ADDENDUM NO. 3

Reference: HVAC and Electrical Systems Upgrade
Ft. Douglas Museum – Phase 2A – Utah National Guard
DFCM Project No. 08249470

PROJECT NAME: Ft. Douglas Museum Phase 2A
Mechanical & Electrical Systems
31 Potter Street
Ft. Douglas, UT 84113

**MAIN LEVEL
OCCUPANCY PLAN**

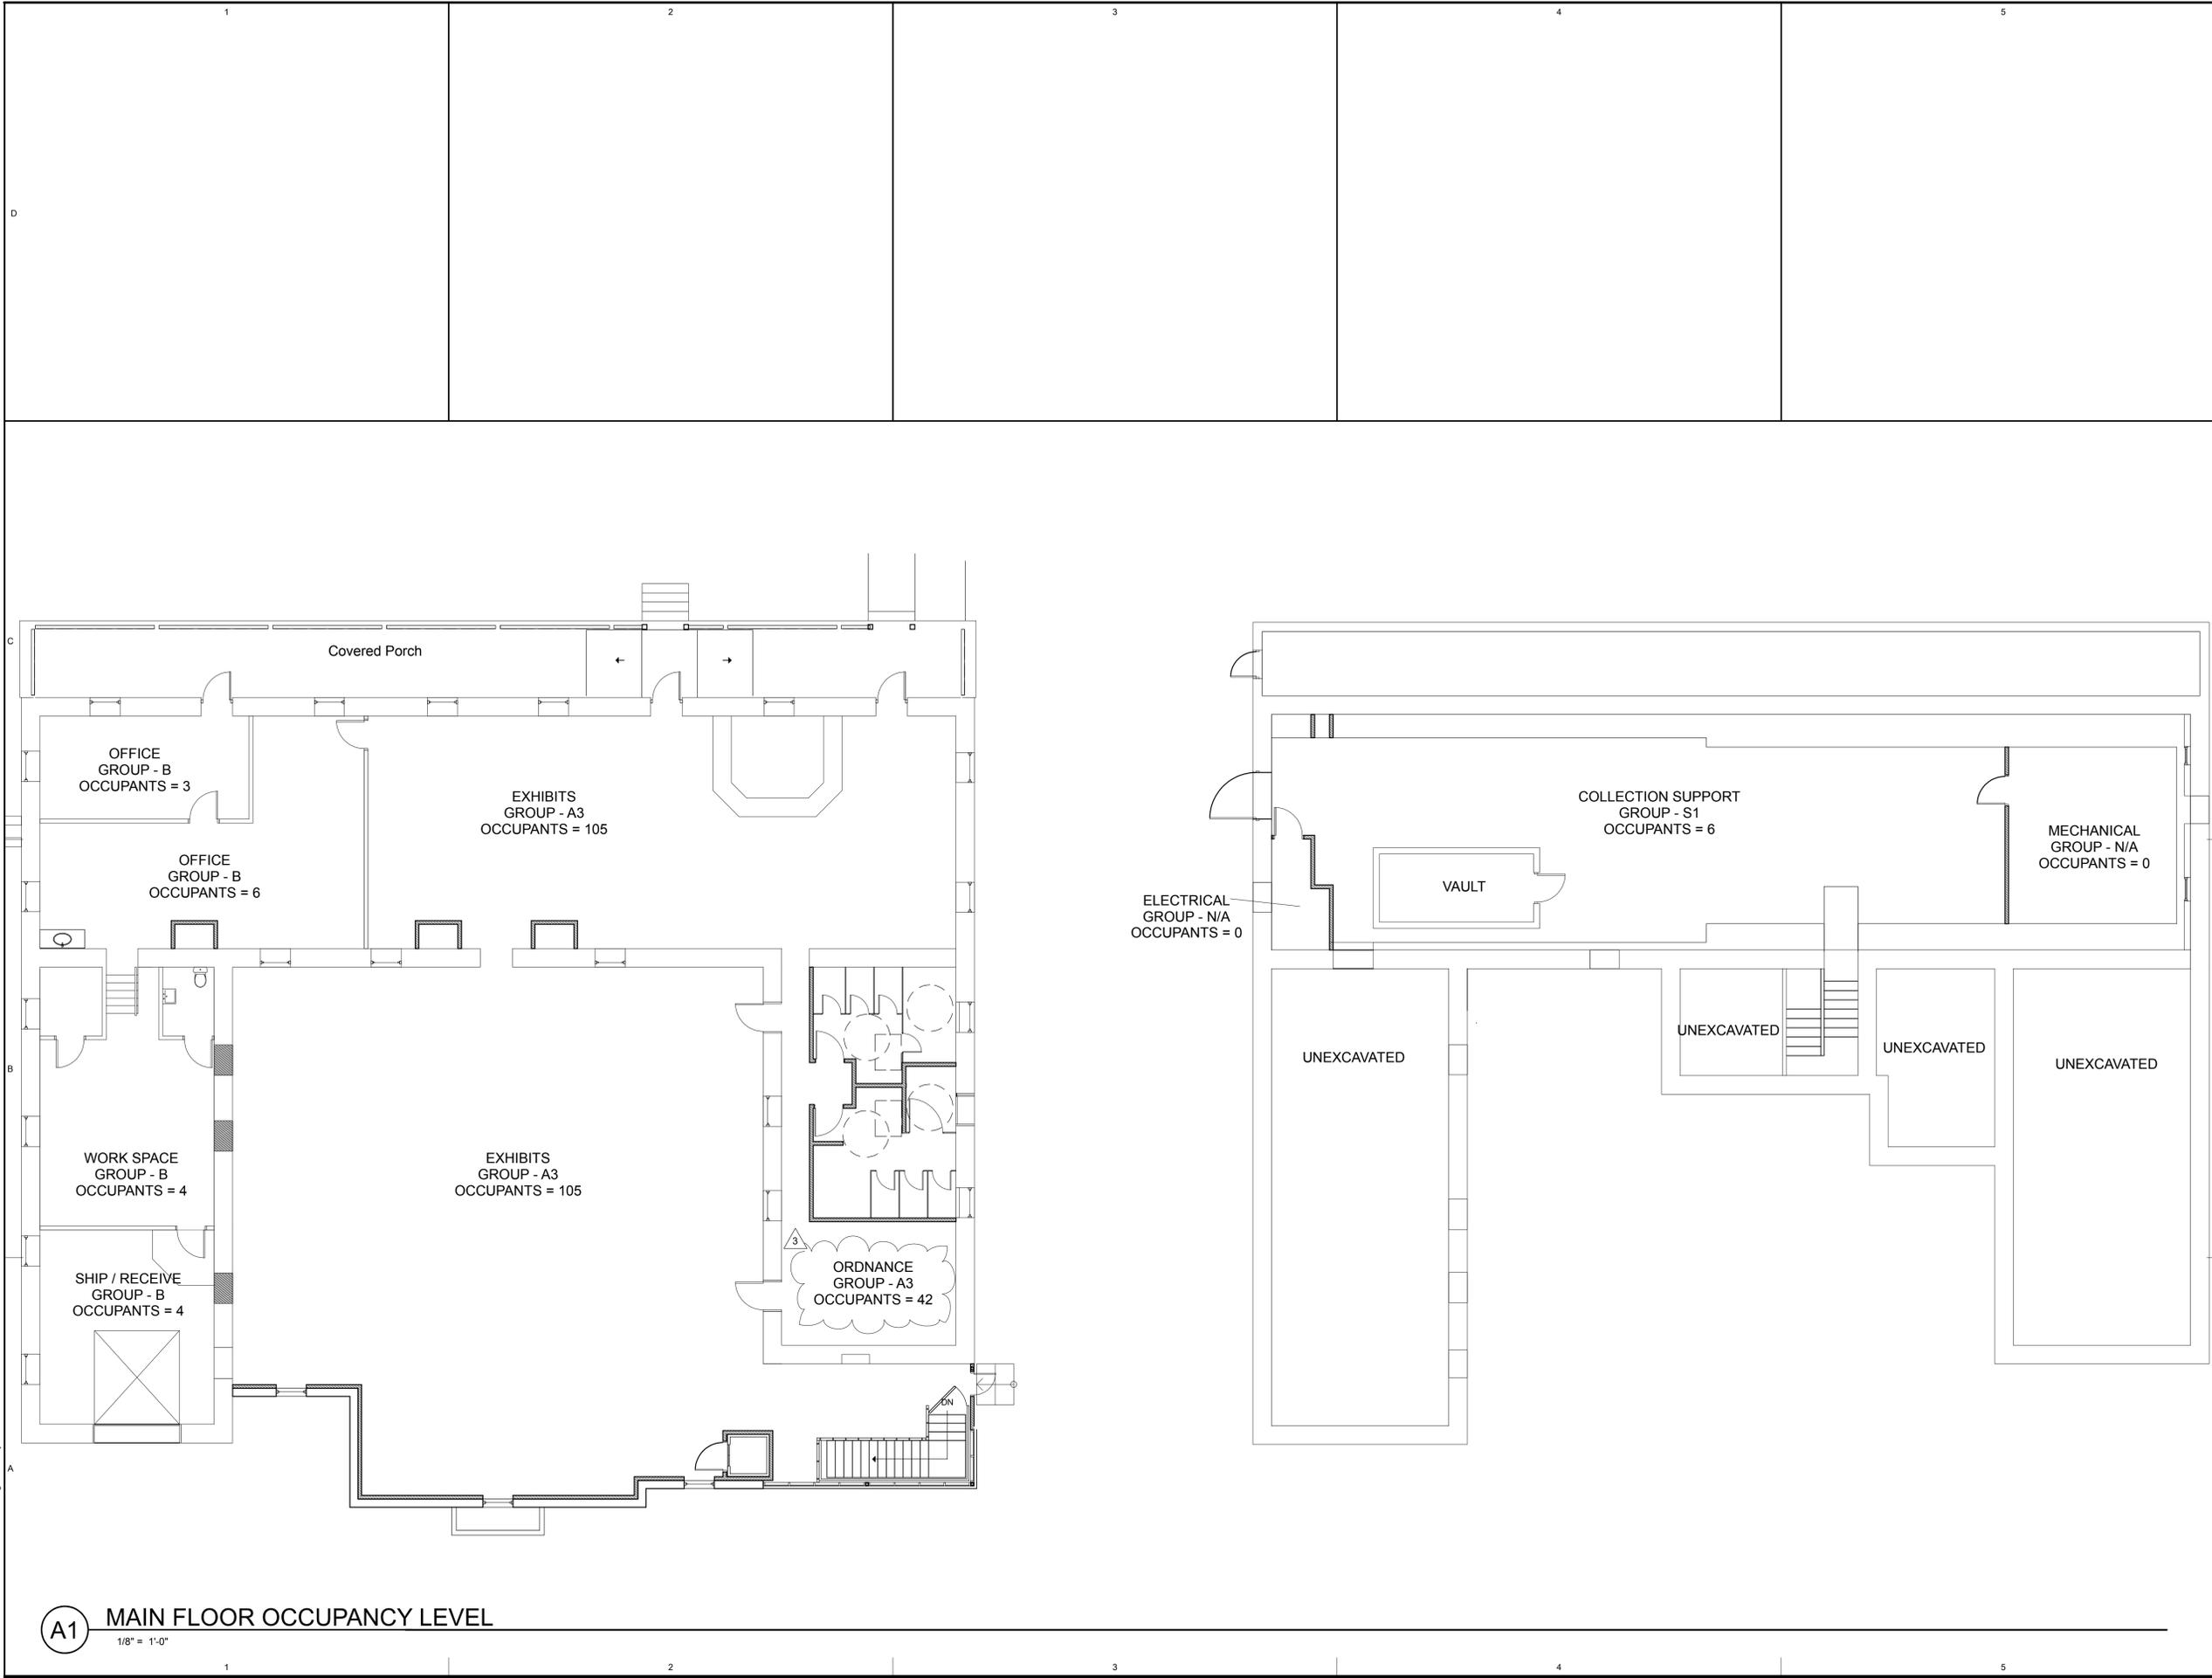
- a) Modified the Code Analysis information.
- VI-3 GI003 Main Level Occupancy Plan
 - a) Changed Ordnance Room from Occupancy Group B to A3.
- VI-4 AS101 Site Plan

SITE PLAN

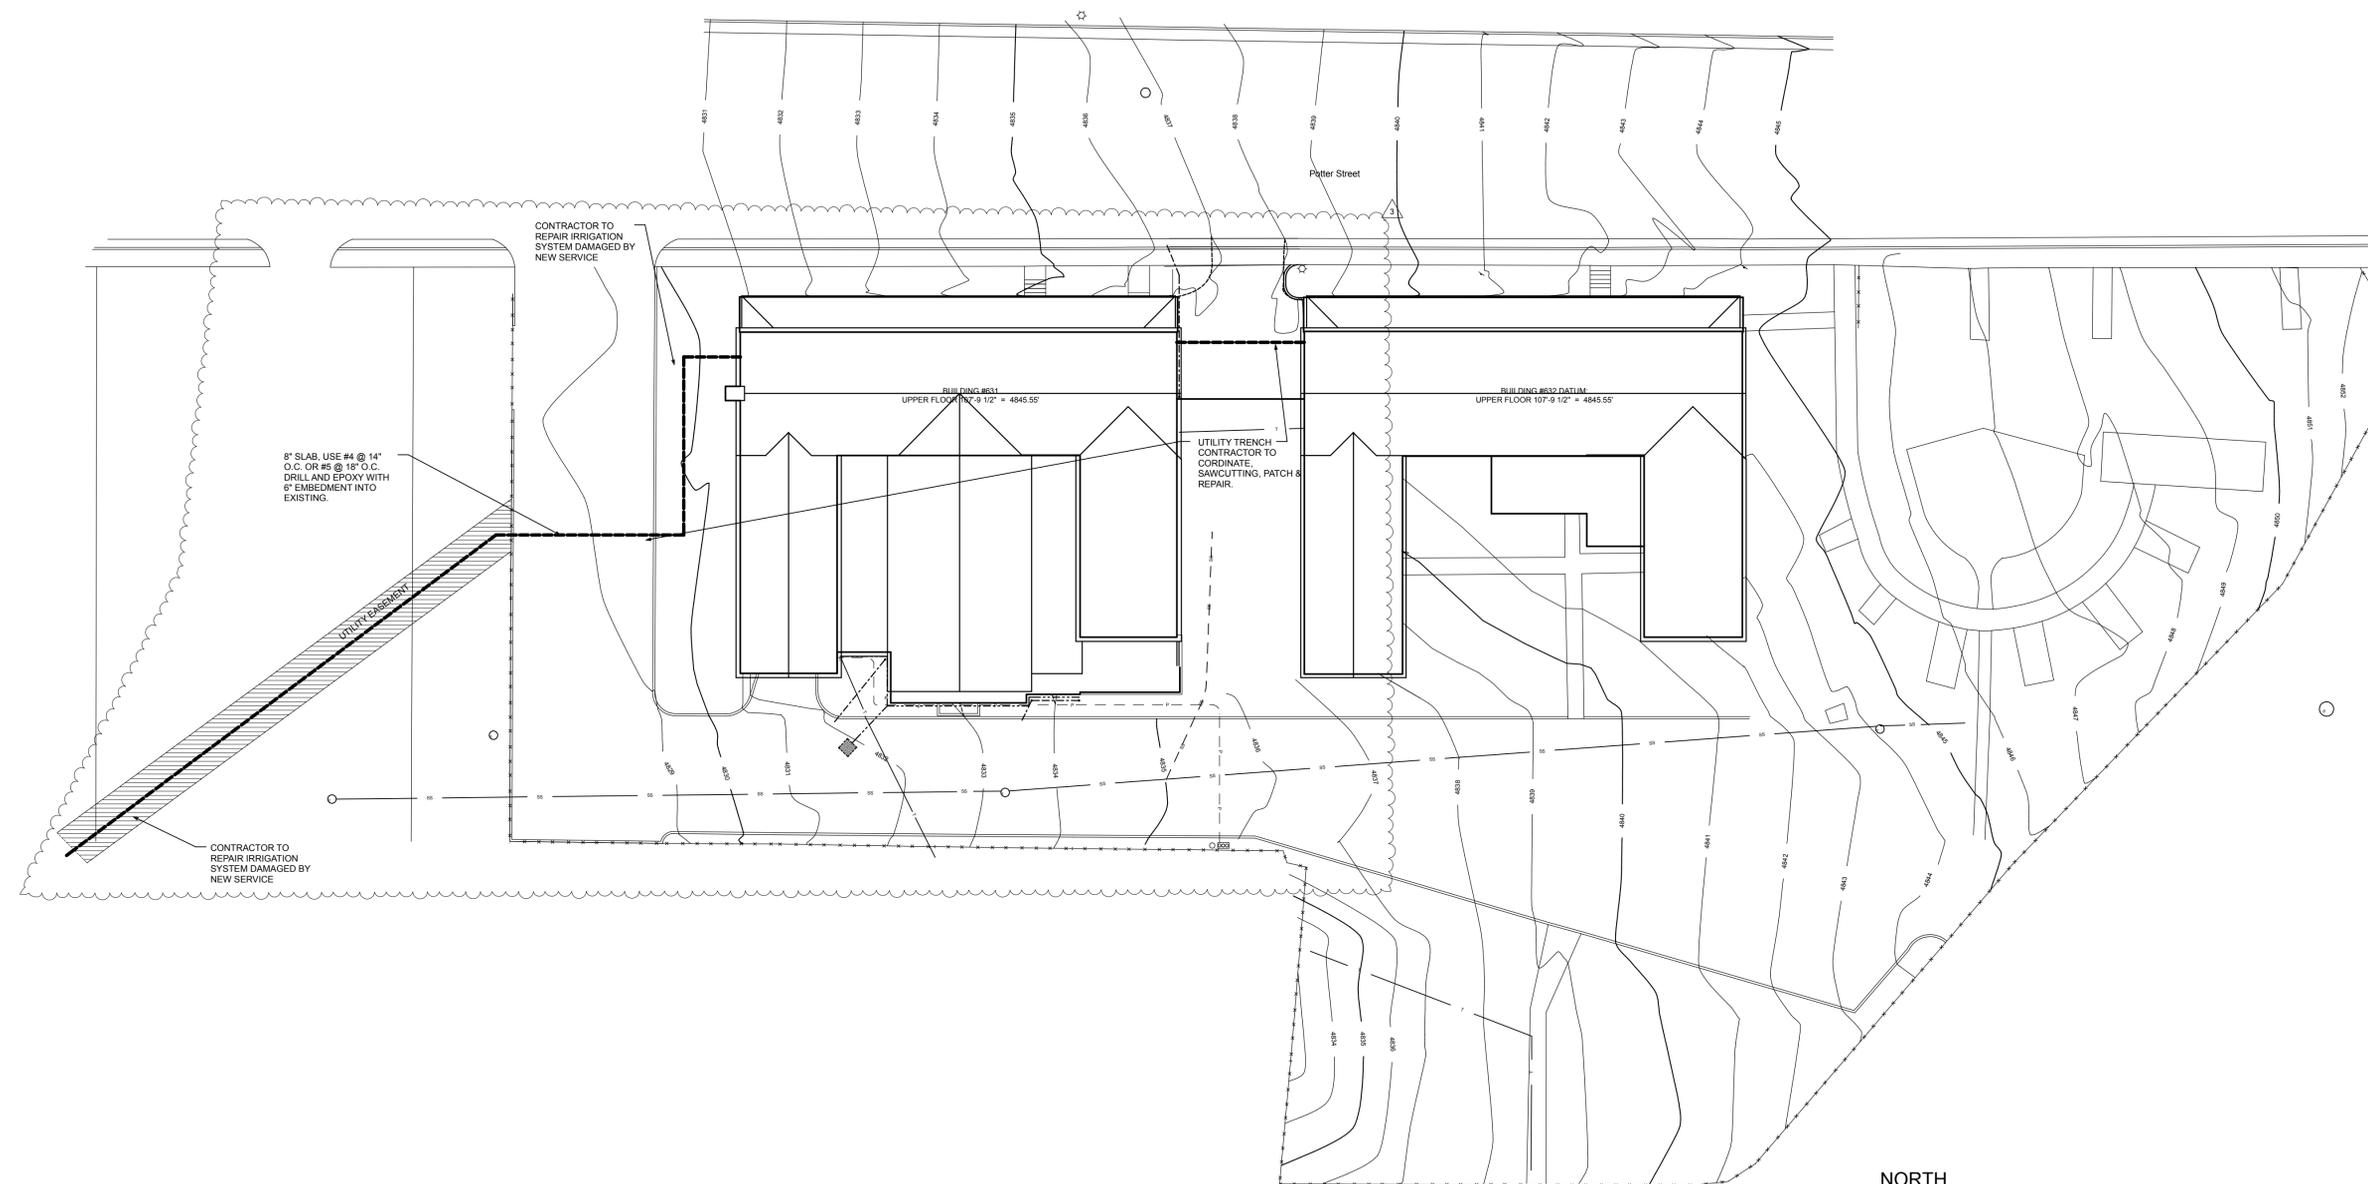
- a) Updated site plan with utility easements and notes for west reinforced concrete slab patching.
- VI-5 AD101 Lower Level Demolition Plan
 - a) Added reference note #4.

LOWER LEVEL
FLOOR PLAN

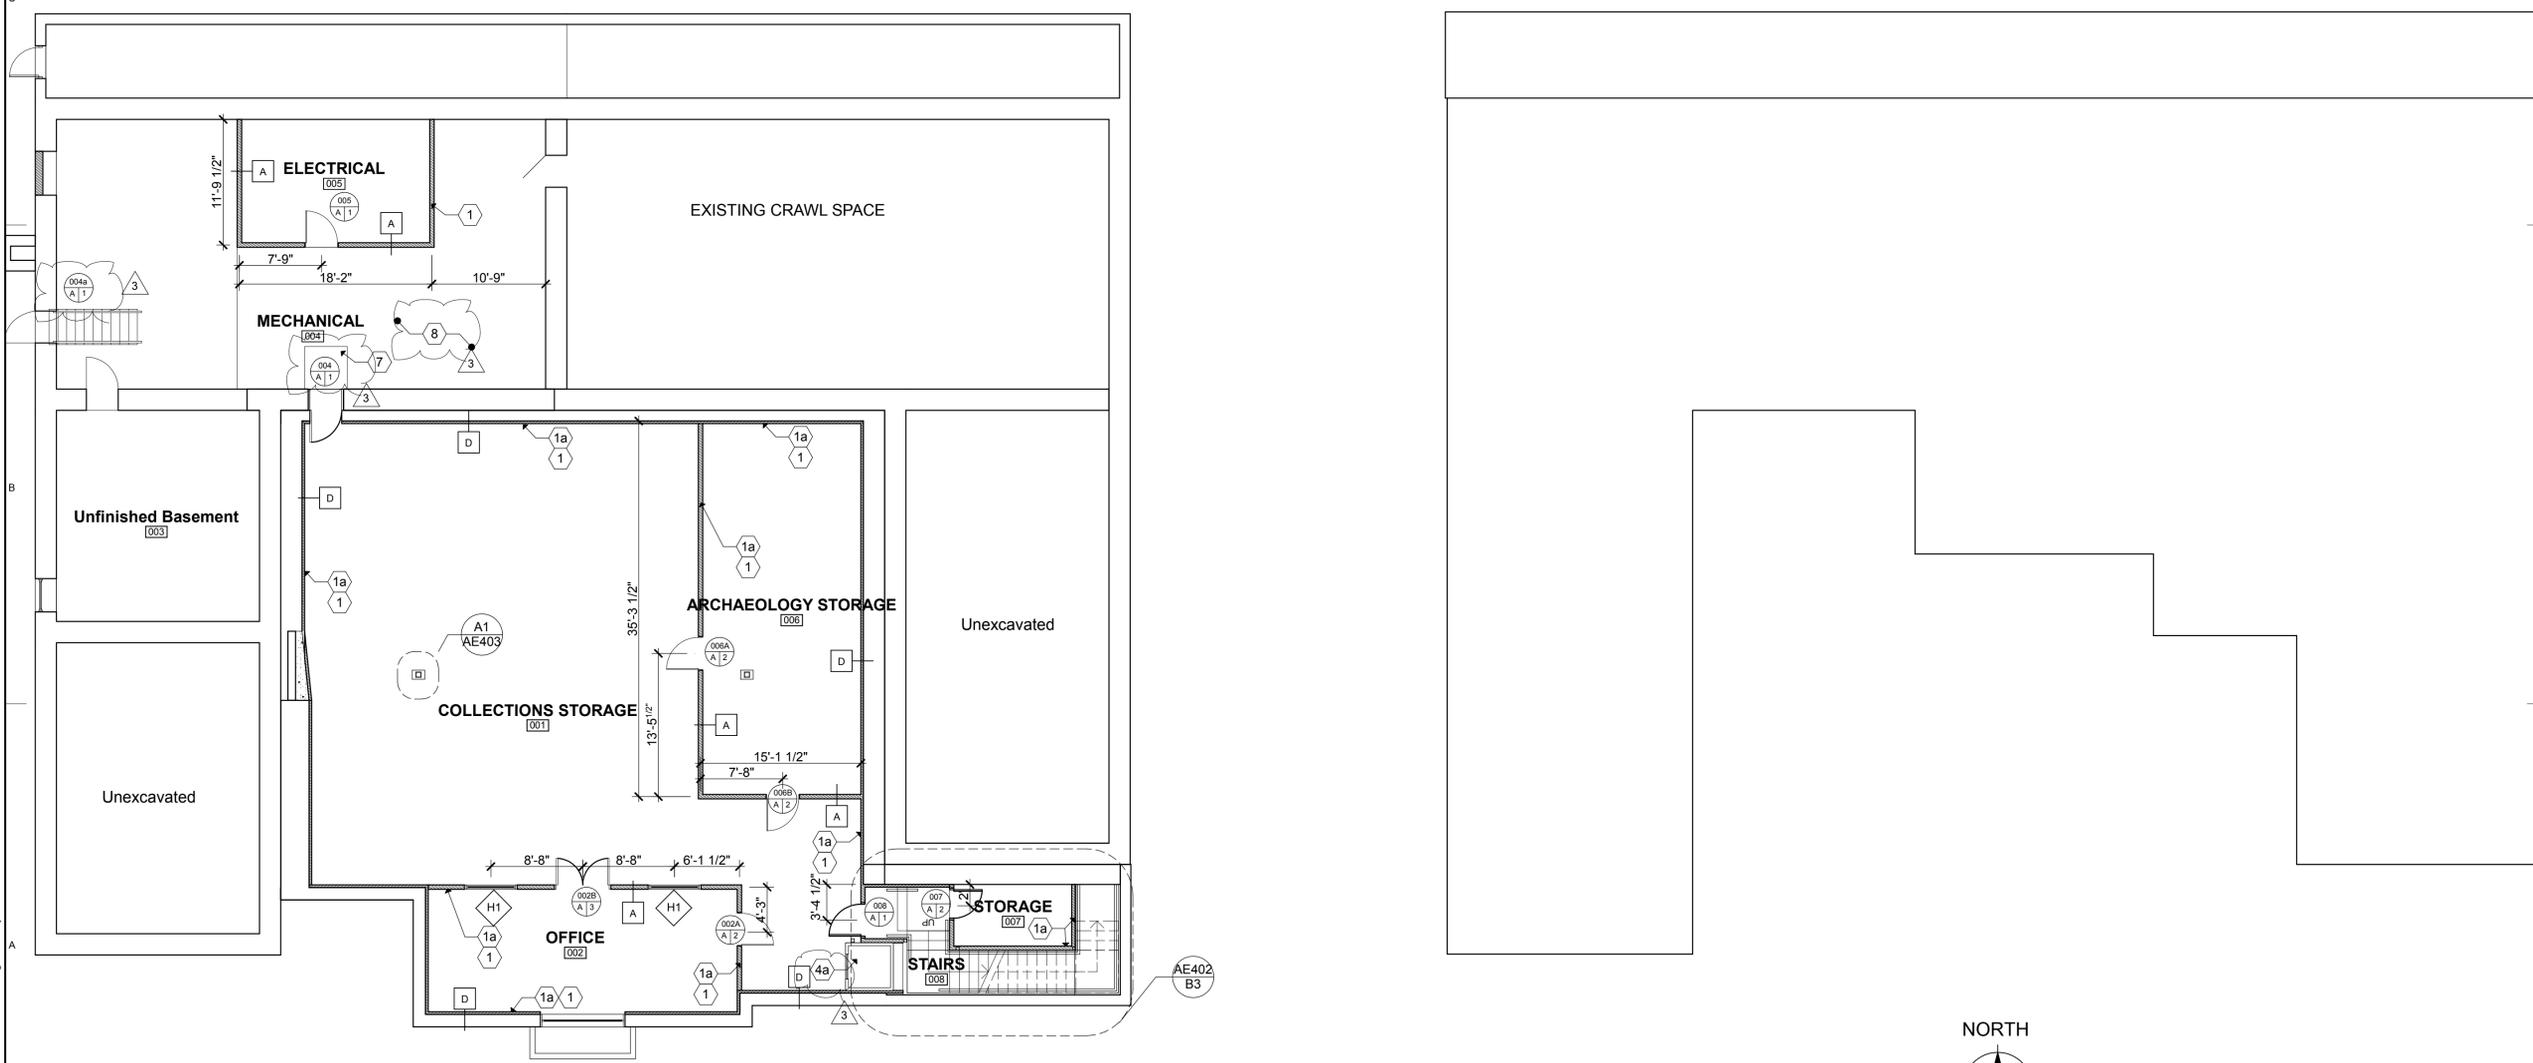
- VI-6 AD103 Main Level Reflected Ceiling Demolition Plan
 - a) Added the attic access demolition and reference note
- VI-7 AE101 Lower Level Floor Plan
 - a) Added door 004A.

- b) Modified Bid Alternate reference notes 3a, 4a, 5a & 6a.
 - c) Added reference notes 6, 7 & 8.
 - d) Added wood floor landing in Mechanical 004.
 - e) Revised reference note 2 to reflect new furred out wall and horizontal shaftwall at floor level in lieu of rated shaft. Note: the construction of this wall remains the same but it is not required to be a fire rated shaft.
